**COOPER NUCLEAR STATION
SEMI-ANNUAL OPERATING REPORT
RADIOACTIVE EFFLUENTS
DOCKET NUMBER 50-298**

January 1, 1983 through June 30, 1983

ERRATA

Subject: Semi-Annual Operating Report - Radioactive Effluents -
Errata
Cooper Nuclear Station
January 1, 1983 through June 30, 1983
NRC Docket No. 50-298, DPR-46

Figure 3 Atmospheric Diffusion Estimate Isopleths, 0-5 Miles
Ground-Level Releases, January-March 1983 (sec/m^3)

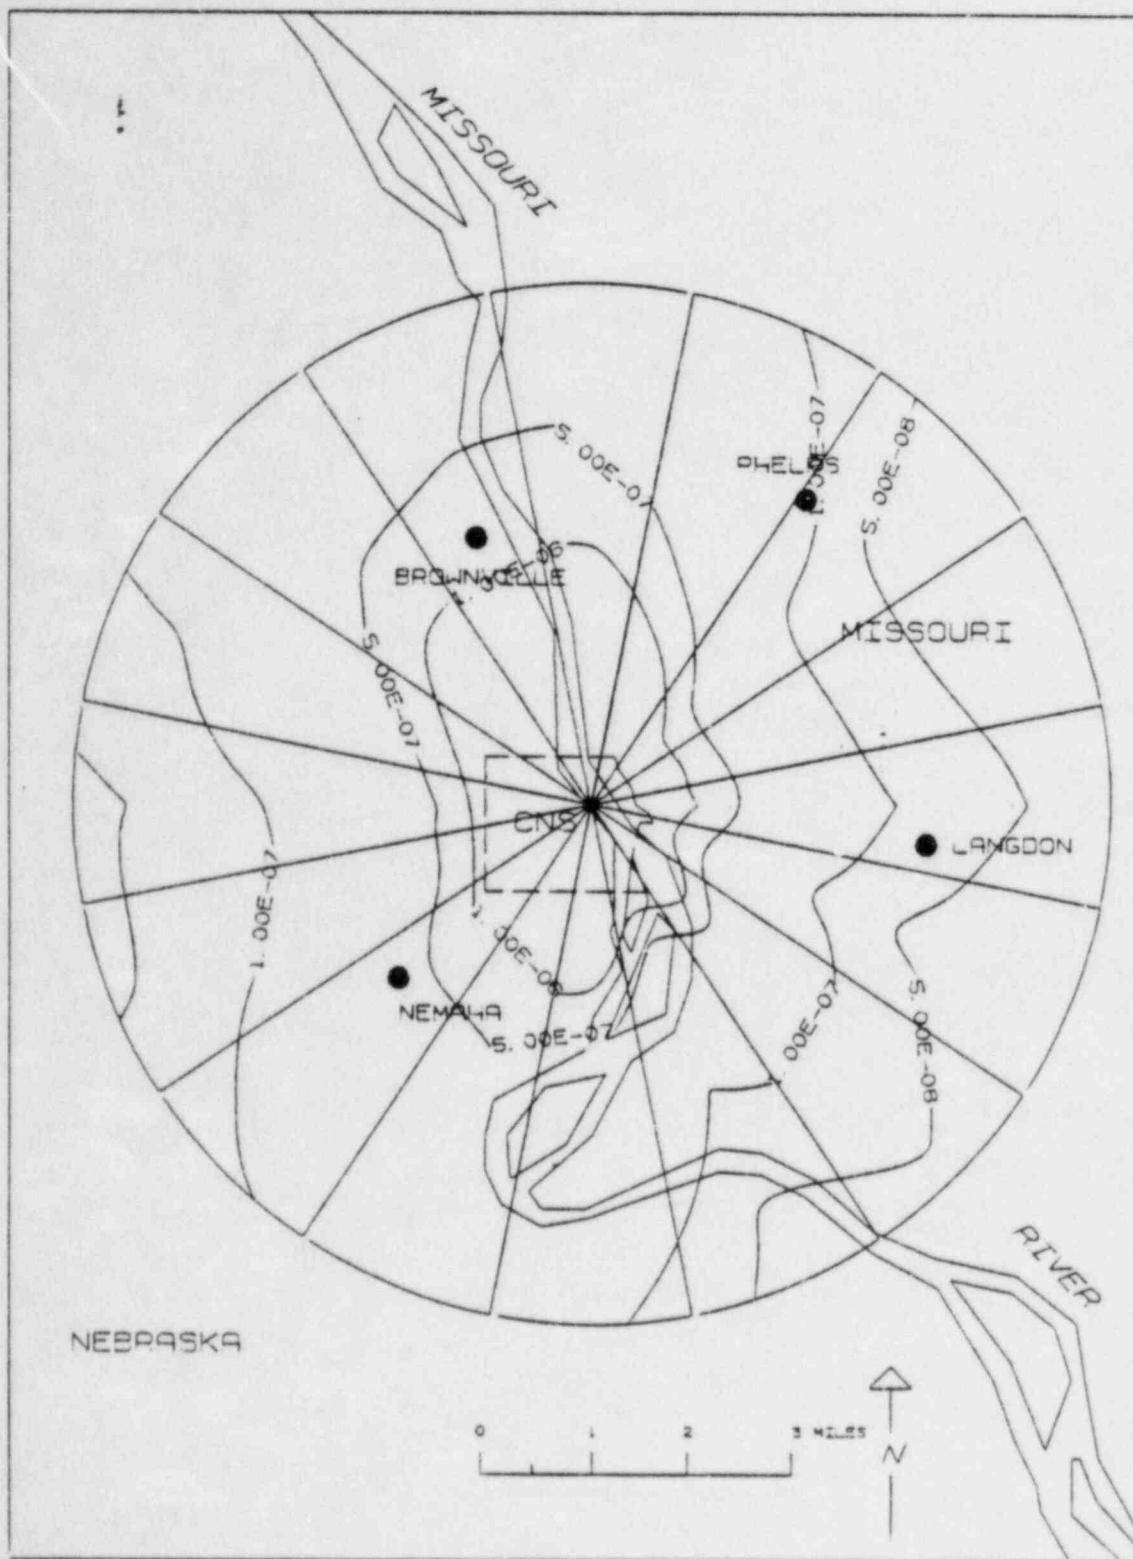
During preparation of the second semi-annual operating report for the Cooper Nuclear Station for the period July 1-December 31, 1983 an error was discovered in the plotting routines used to generate the Chi/Q and dose isopleths. This error resulted in a rotation of contours one sector (22.5°) counter clockwise from what they should have been.

The plotting program was corrected, and the plots contained in the July 1, 1983 - December 31, 1983 semi-annual report are correct. However, the plots provided in Appendix C of the first semi-annual report for January 1-June 30, 1983, contain the same error. Attached are corrected versions of Figures 3-20 of the January 1, 1983 - June 30, 1983 semi-annual report.
